BURR STREET

S96A NON-MATERIAL AMENDMENT APPLICATION — PROPOSED REVISIONS

This document has been prepared on behalf of the applicant to illustrate the proposed revisions that are being sought under this S96A non-material amendment application, when compared to the scheme that was previously approved under planning ref: 22/00807/MMAMD

REVISED 8th FLOOR PLAN

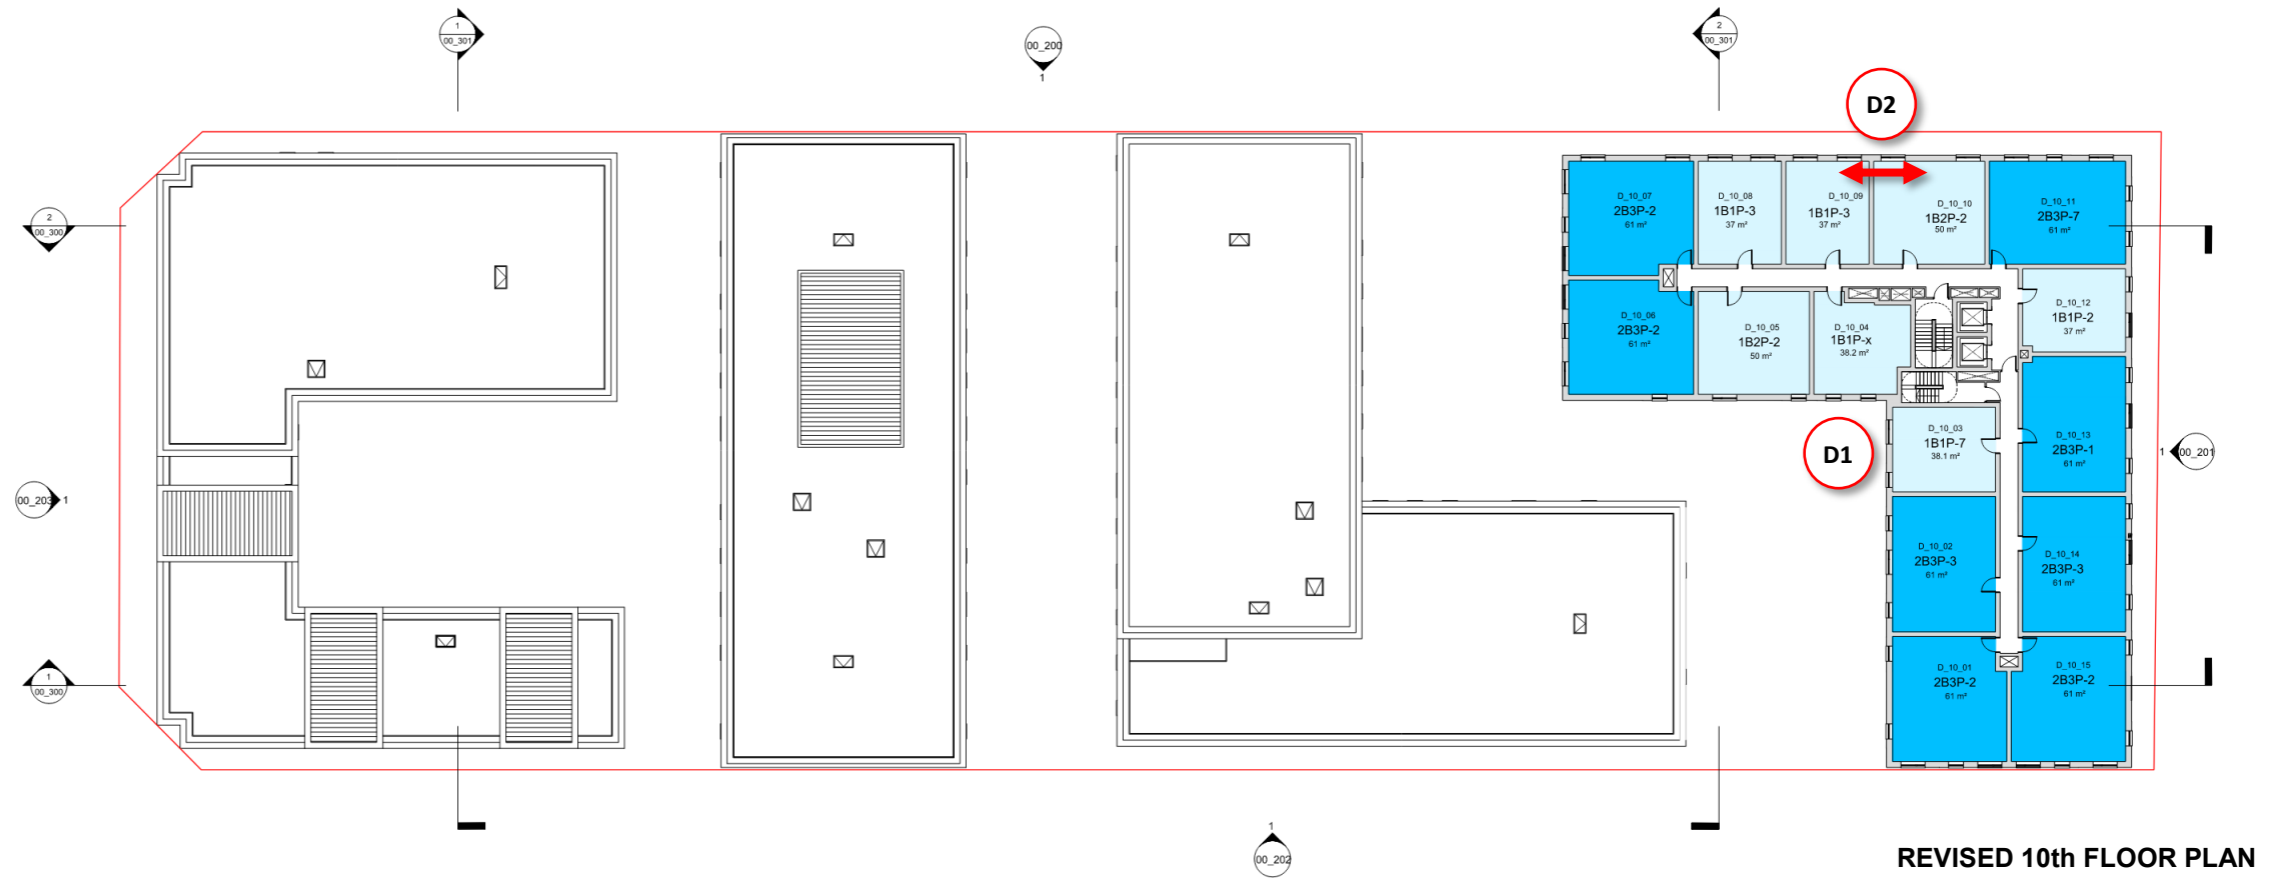
B1: Roof plant enclosure relocated slightly.

C1: Lift / Stair core revised for the addition of second stairs. Minor change in floor areas of the 1B1B unit beside the core

D1: Lift / Stair core revised for the addition of second stairs. Minor change in floor areas of the 2 x 1B1B units on either side of the core

D2: Positions of 1B2P and 1B1P units swapped, with associated minor amendments to window positions on north elevation.

REVISED 10th FLOOR PLAN

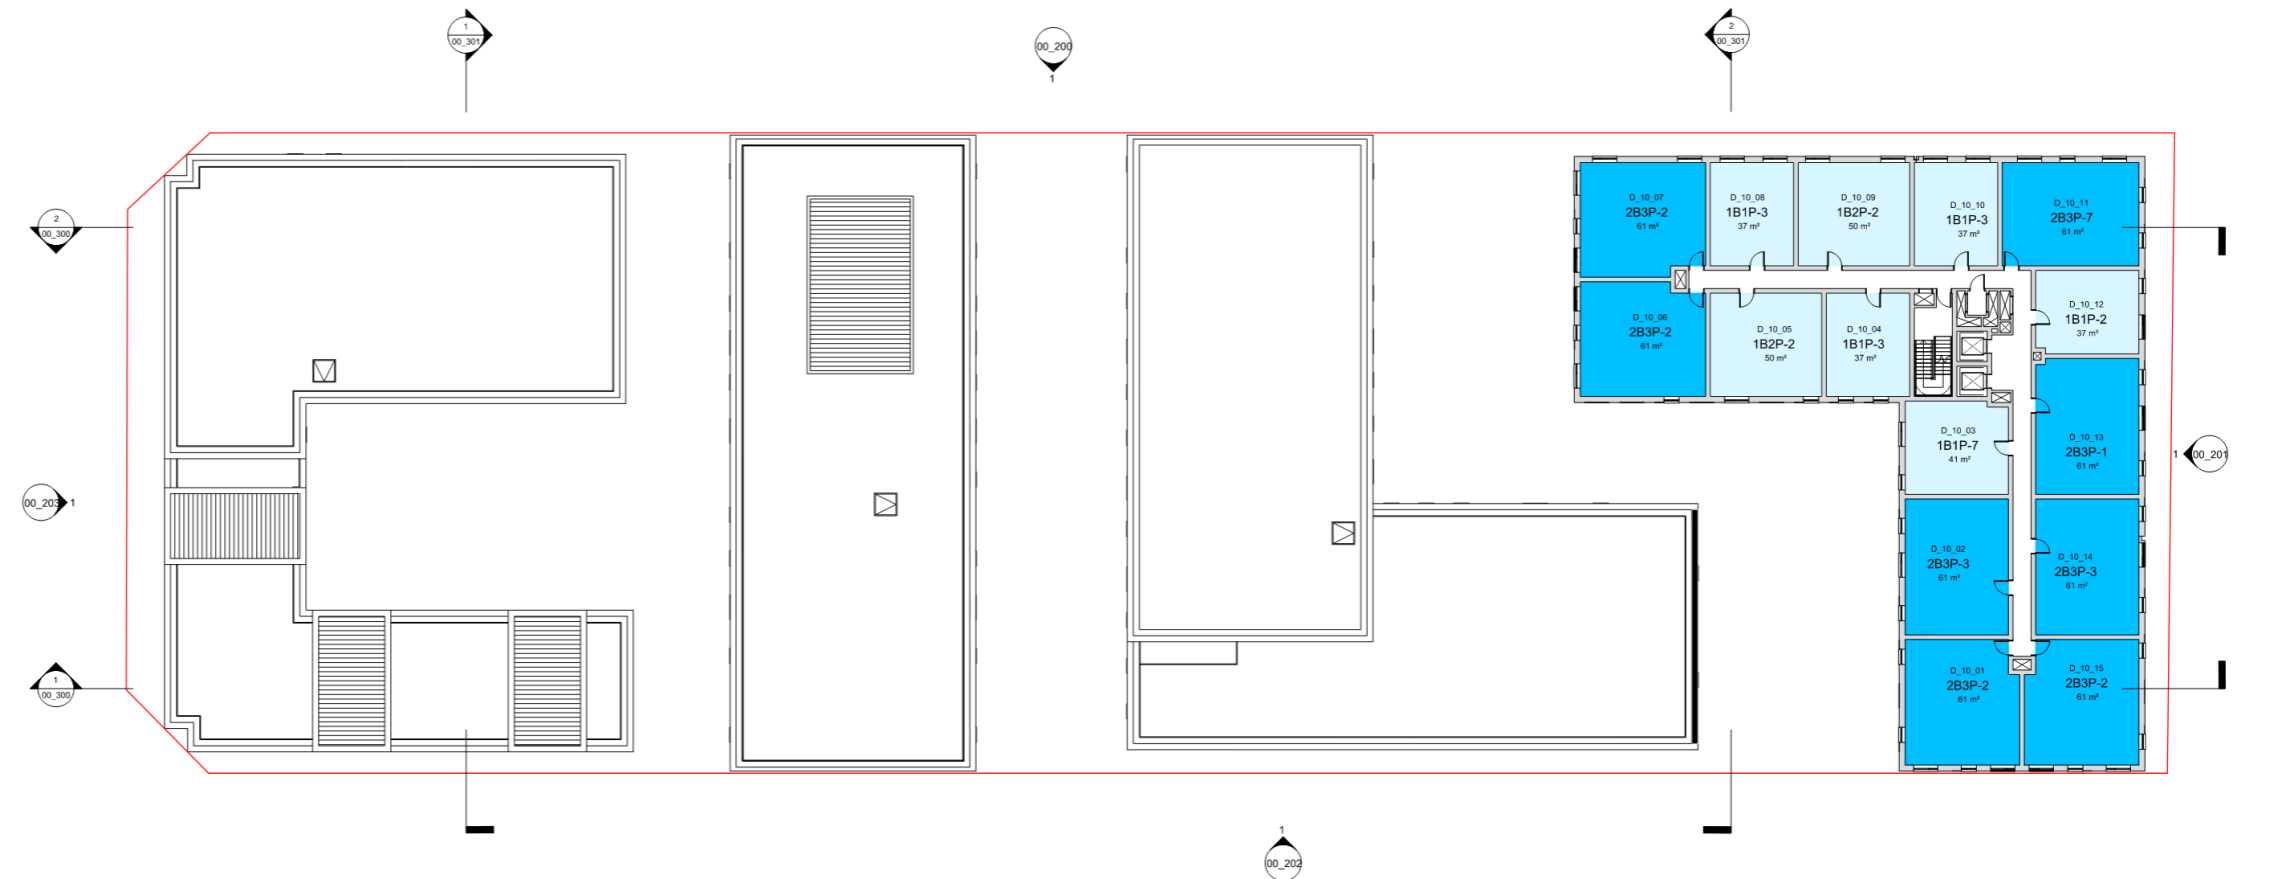
D1: Lift / Stair core revised for the addition of second stairs. Minor change in floor areas of the 2 x 1B1B units on either side of the core
D2: Positions of 1B2P and 1B1P units swapped, with associated minor amendments to window positions on north elevation.

REVISED NORTH ELEVATION

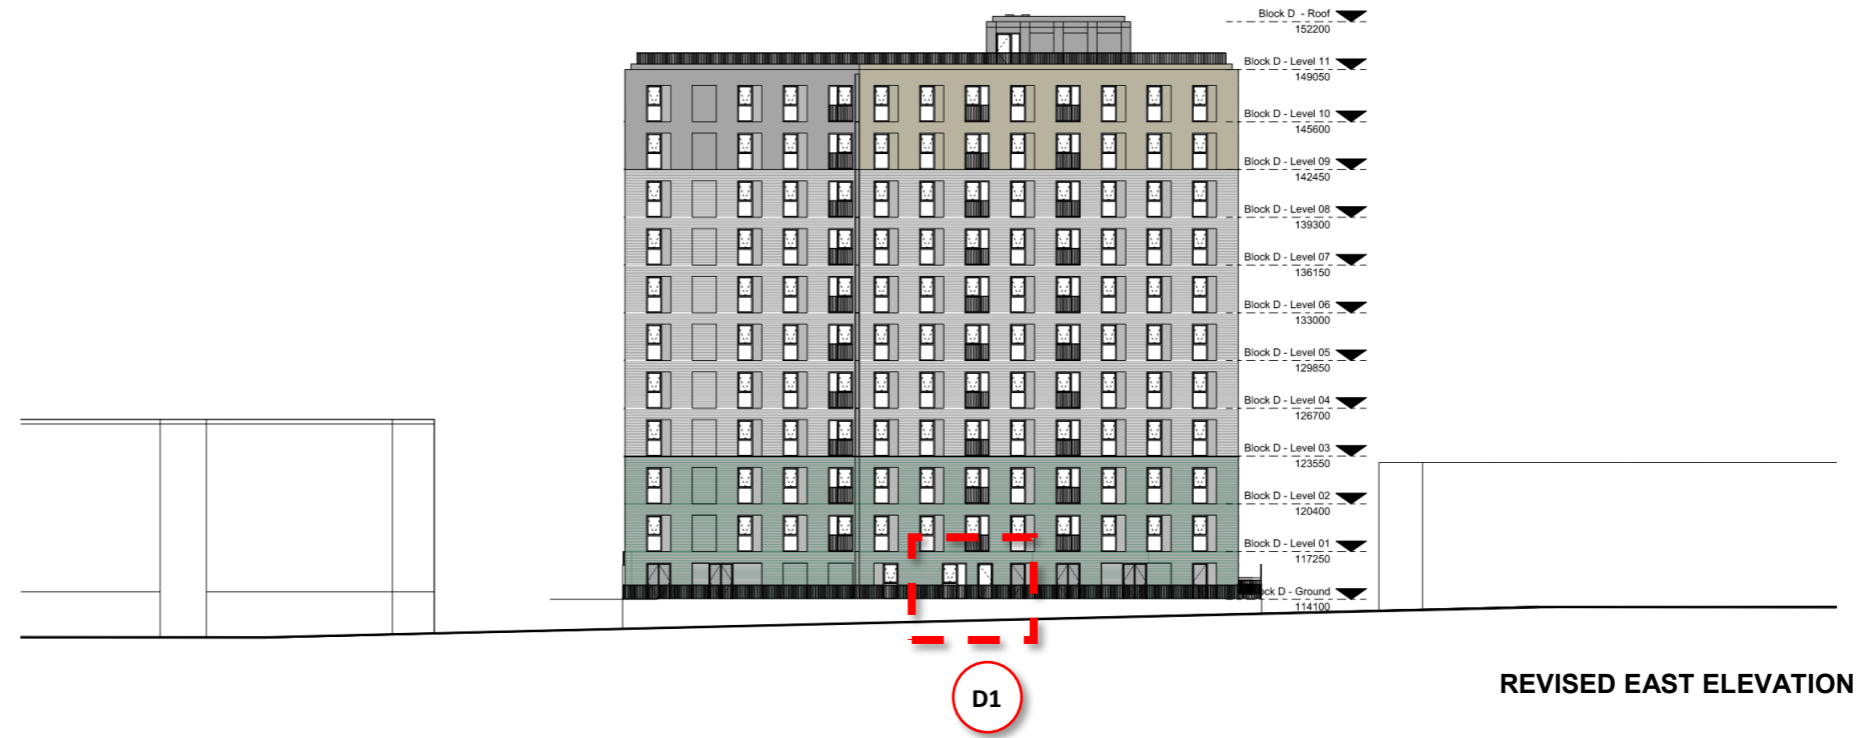
D1: Minor amendment to window positions to facilitate positions of 1B2P and 1B1P units being swapped.
